**Lee Nuclear Station Units 1 and 2
Description, Scope of Changes, and FSAR Impacts due to Plant Relocation and
Additional Design Enhancements**

**Description and Rationale for Lee Nuclear Station Units 1 and 2 Relocation and
Additional Design Enhancements**

FIGURE 2.4.3-247

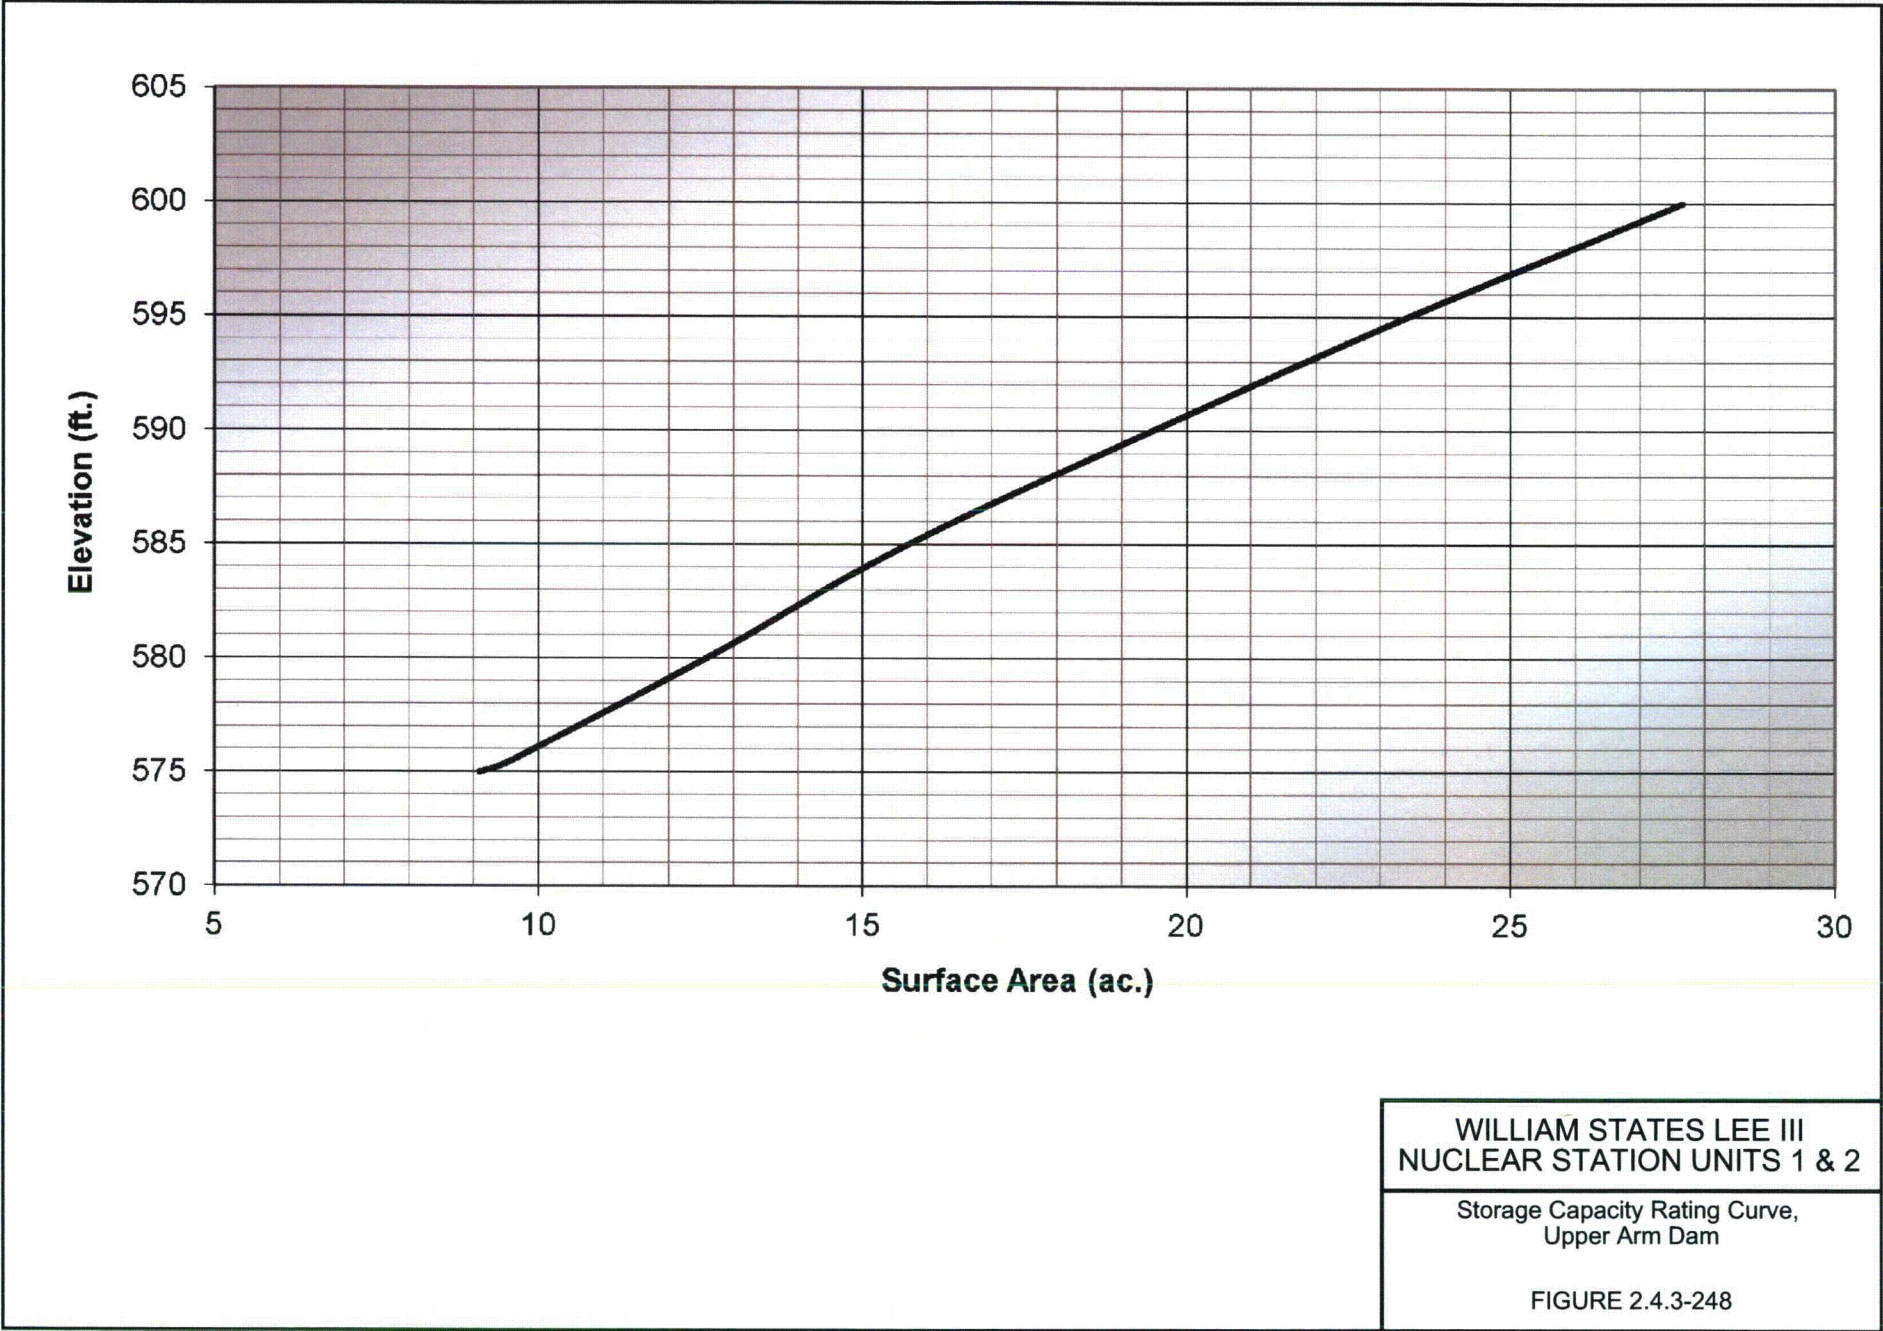
58. COLA Part 2, FSAR Chapter 2, Figure 2.4.3-247 is revised as follows:

FIGURE 2.4.4-201

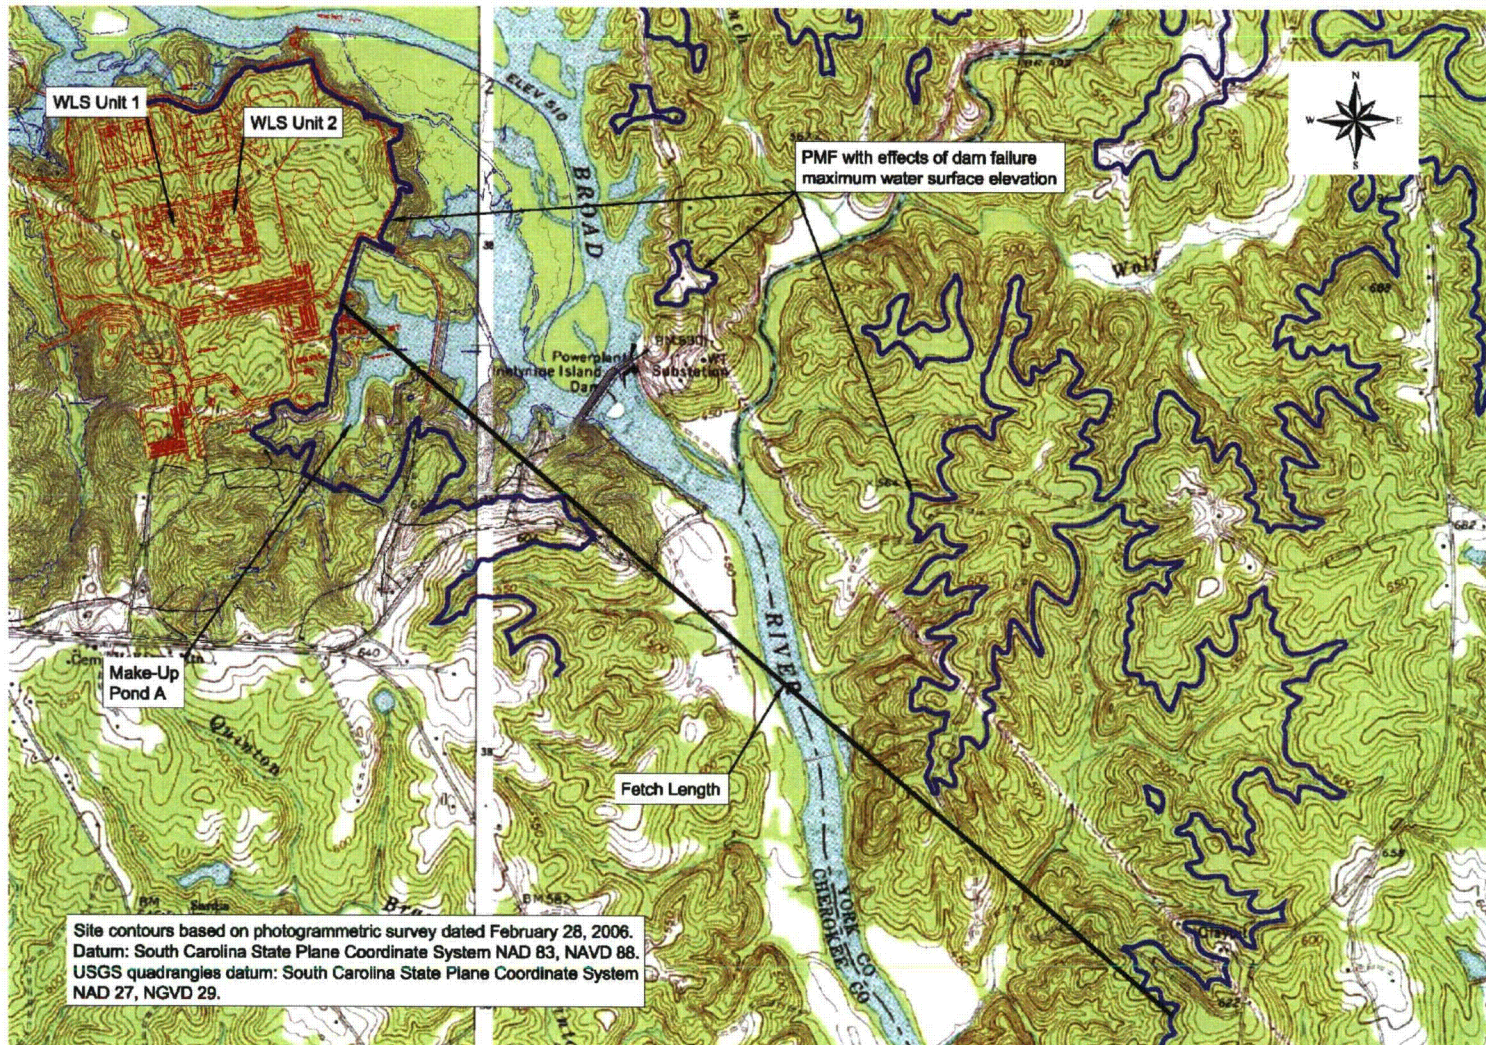
Wind wave activity on the Broad River is evaluated coincident with the maximum water surface elevation of the PMF including the effects of dam failures as discussed above. The determined fetch length of 2.77 mi., shown in Figure 2.4.4-201, has a runup slope of 40 percent. The PMF including effects of dam failures and the coincident wind wave activity results in a flood elevation of 584.79 ft. msl. The Lee Nuclear Station safety-related plant elevation is ~~590~~ 593 ft. msl and is unaffected by flood conditions and coincident wind wave activity. A more critical wind wave activity result was determined considering a fetch length through Make-Up Pond A, which becomes inundated by backwaters of the Broad River during severe flooding events. Therefore, the critical wind wave activity for the Broad River is equal to the wind wave activity for Make-Up Pond A, as discussed below.

60. COLA Part 2, FSAR Chapter 2, Figure 2.4.4-201 is revised as follows:

FIGURE 2.4.4-202

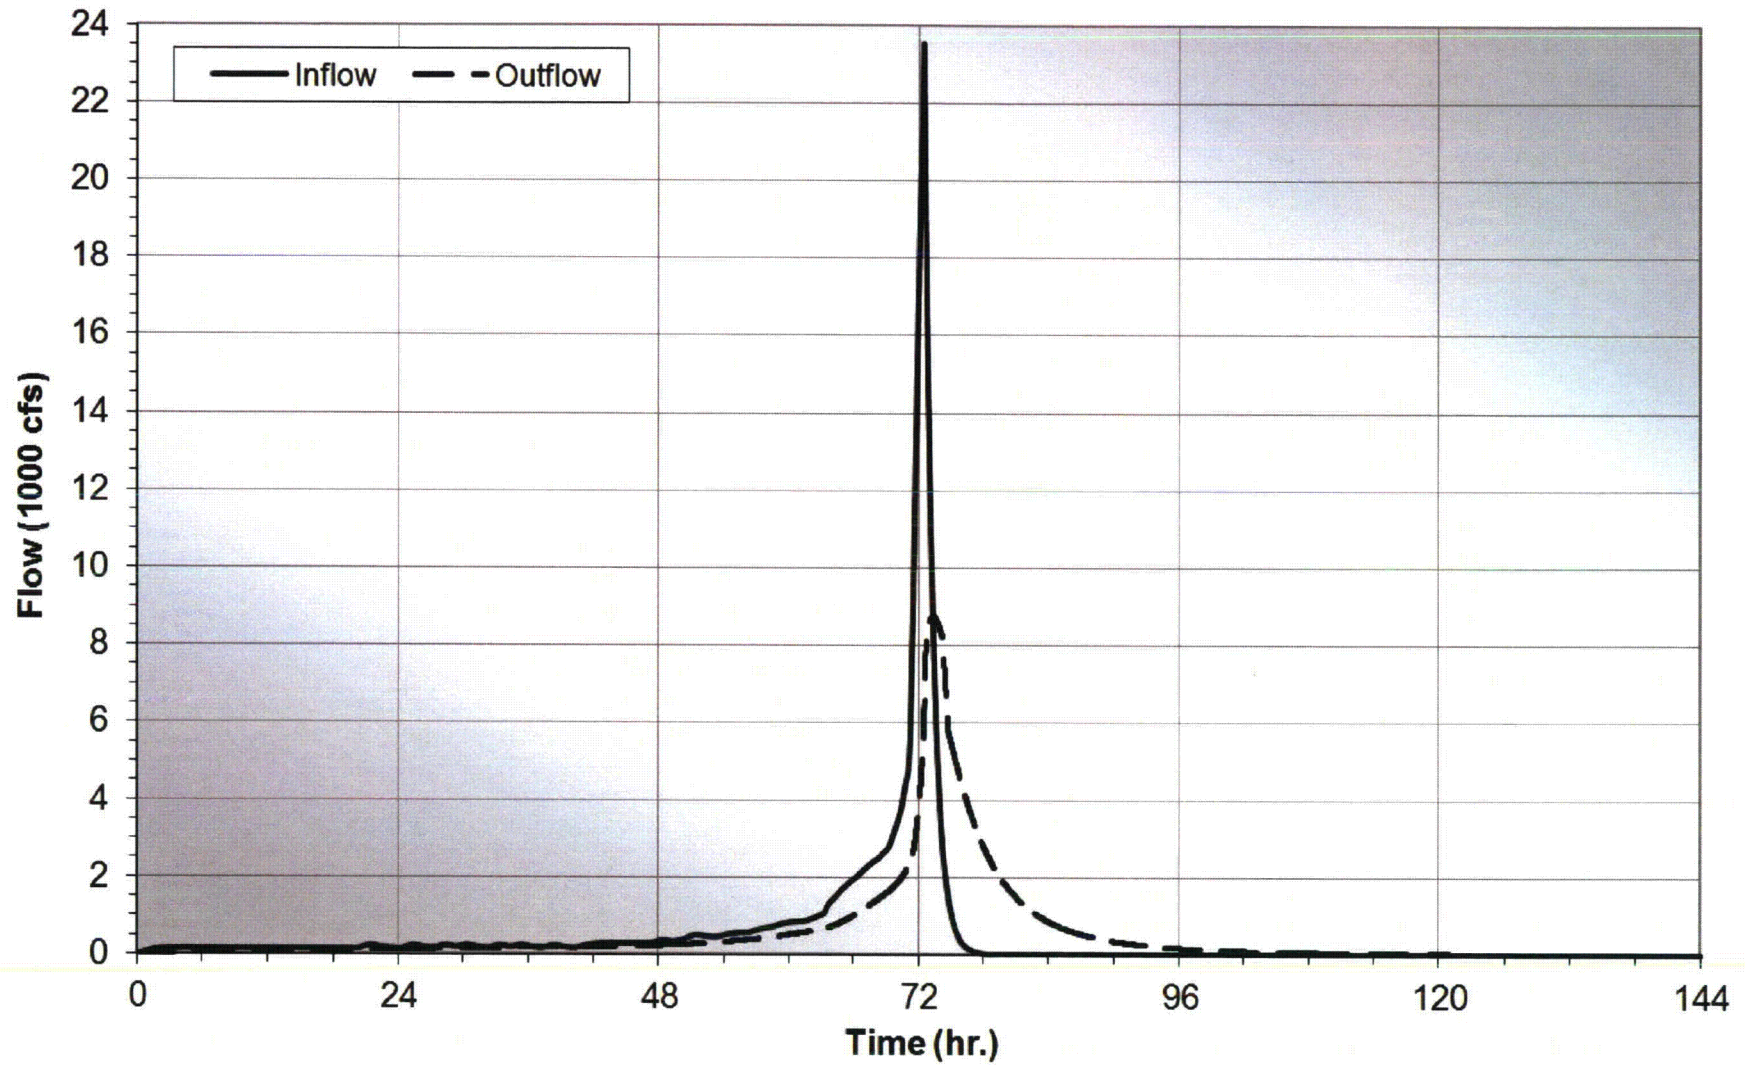
61. COLA Part 2, FSAR Chapter 2, Figure 2.4.4-202 is revised as follows:

FIGURE 2.4.4-203

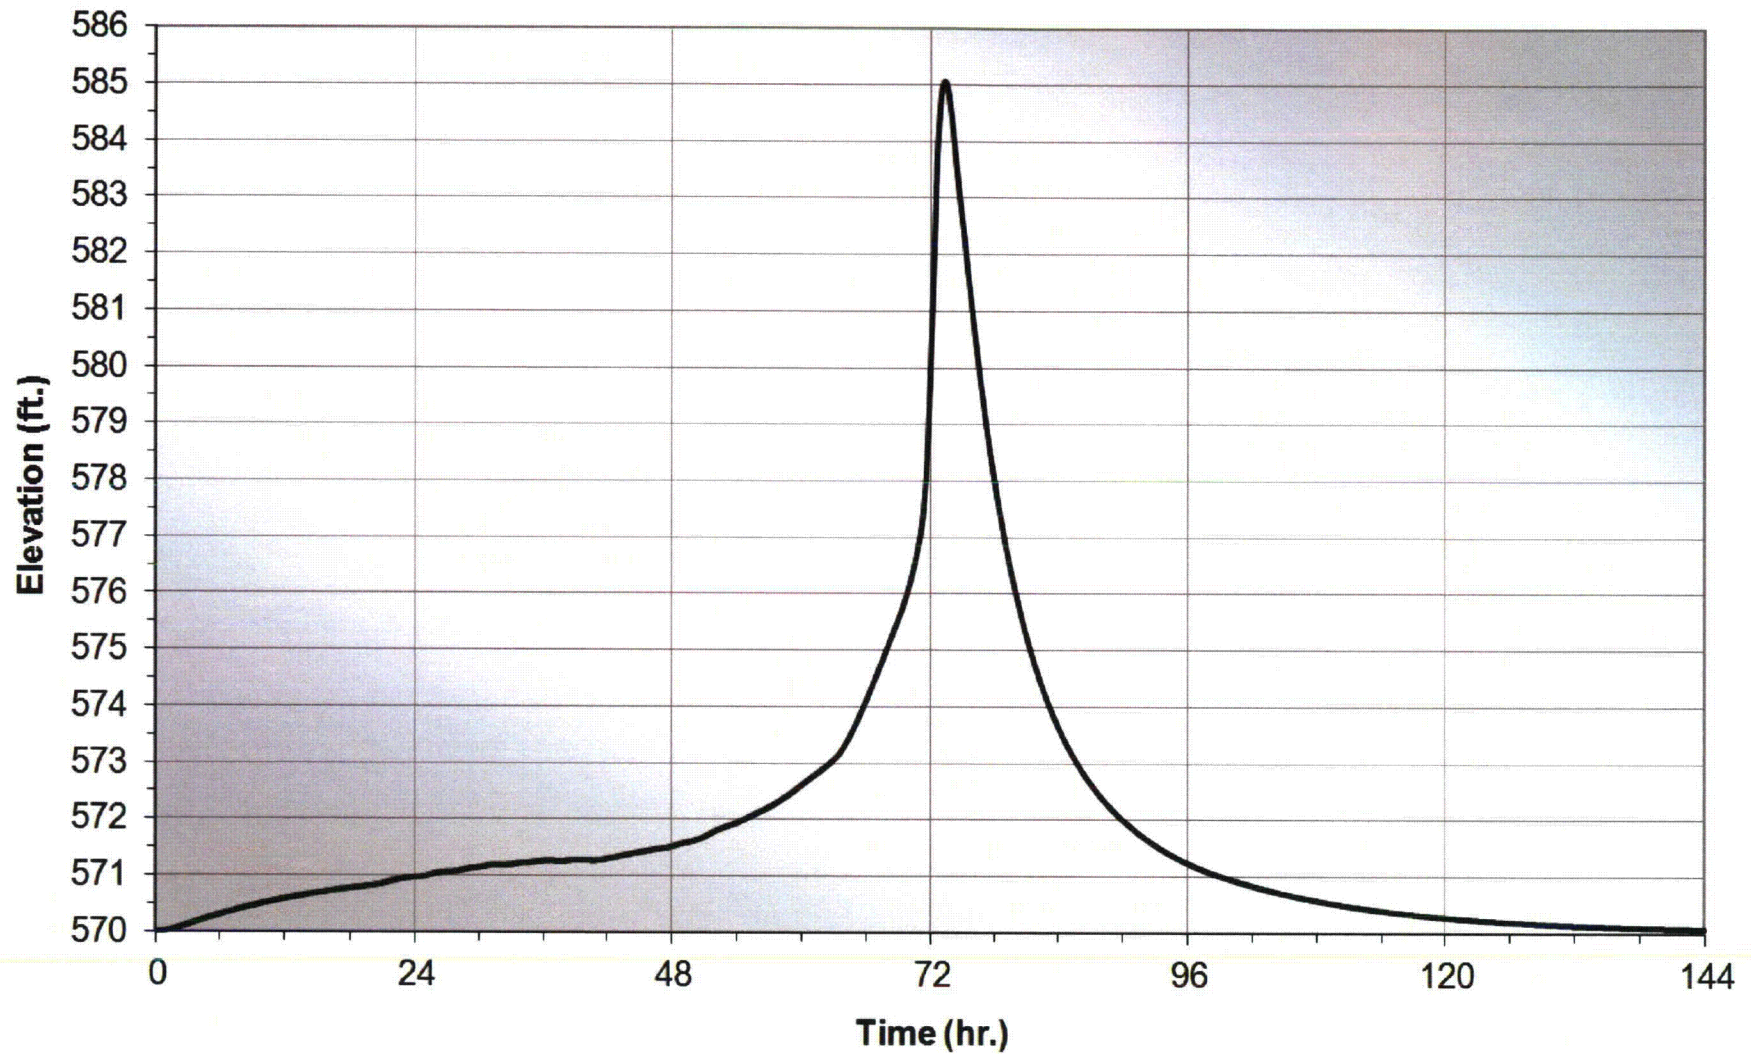
62. COLA Part 2, FSAR Chapter 2, Figure 2.4.4-203 is revised as follows:

FIGURE 2.4.4-205

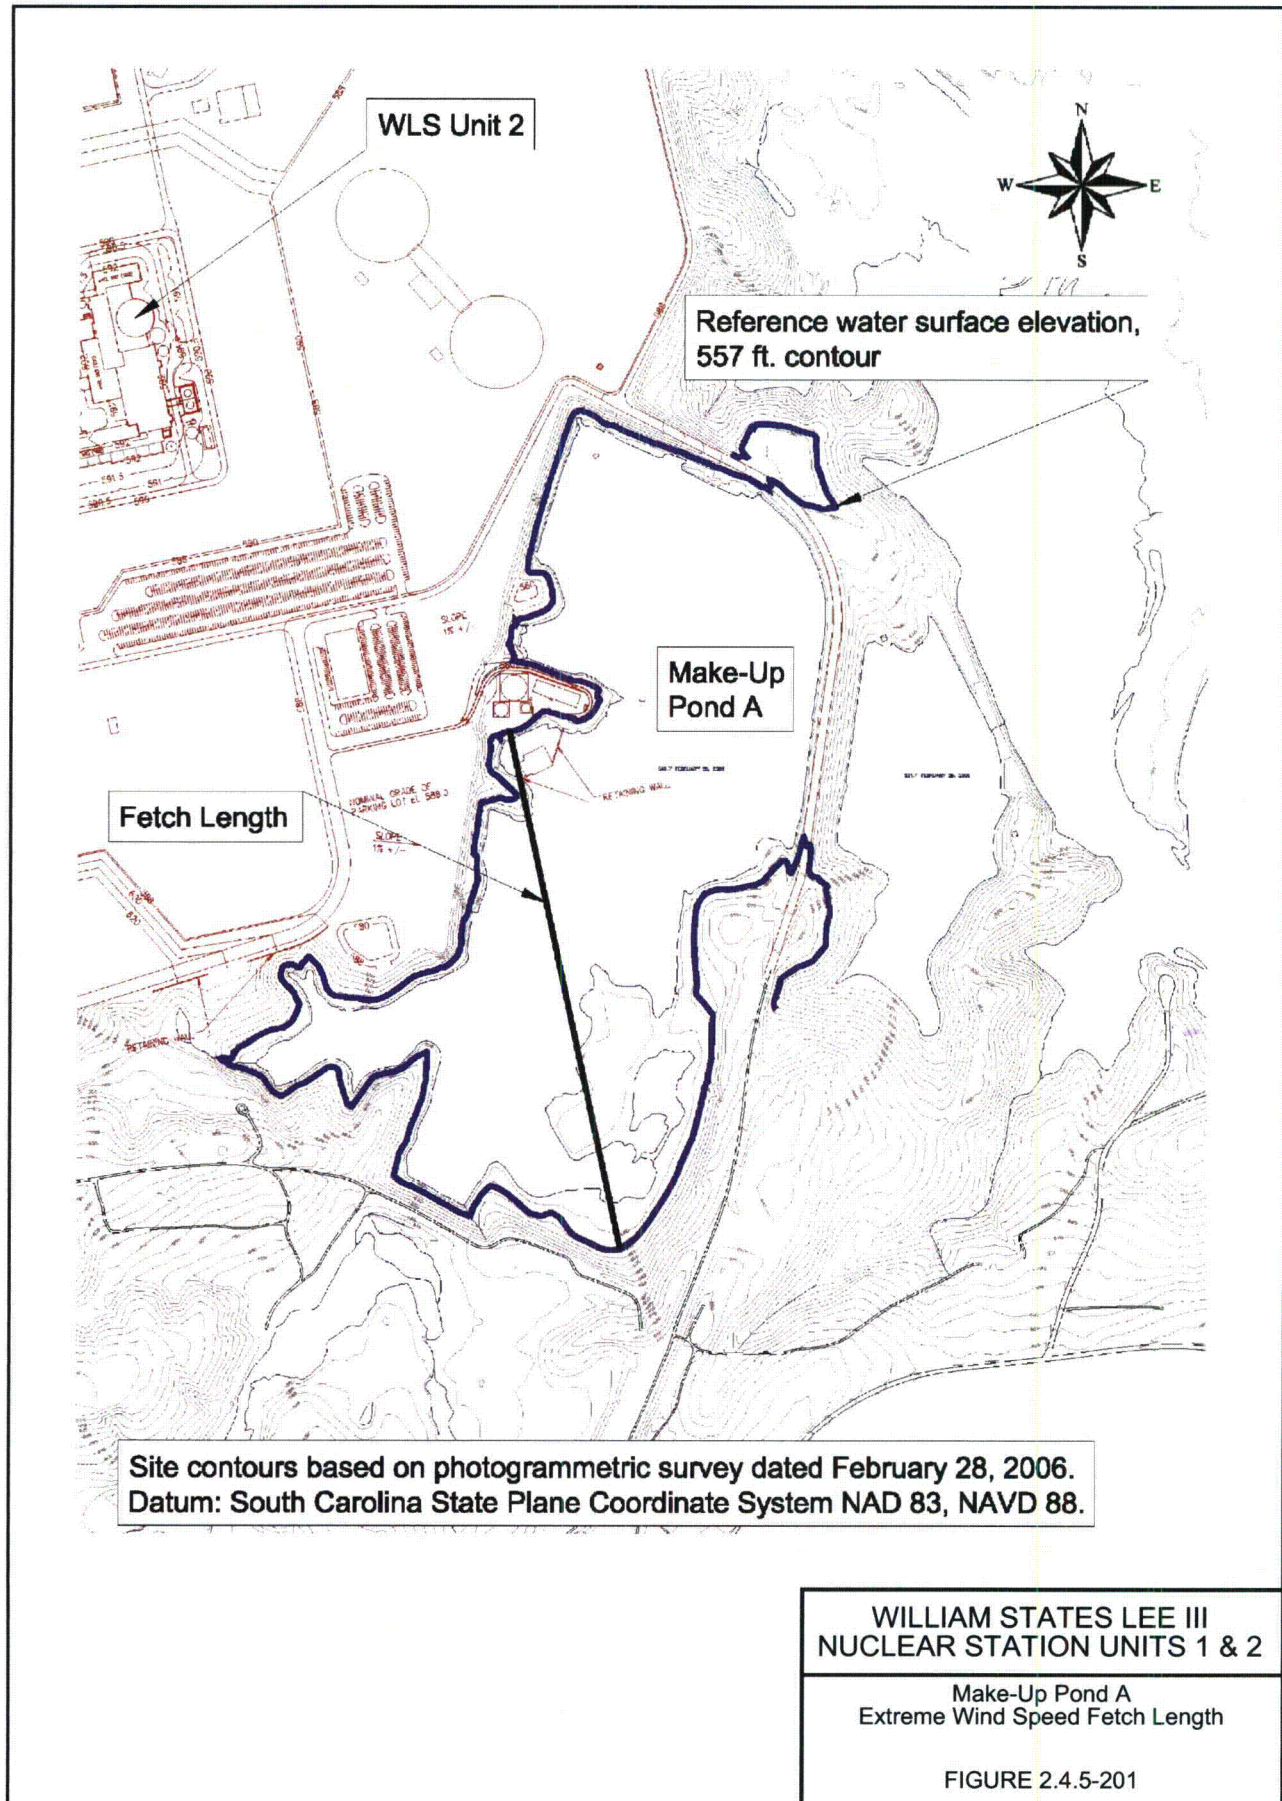
63. COLA Part 2, FSAR Chapter 2, Figure 2.4.4-205 is revised as follows:
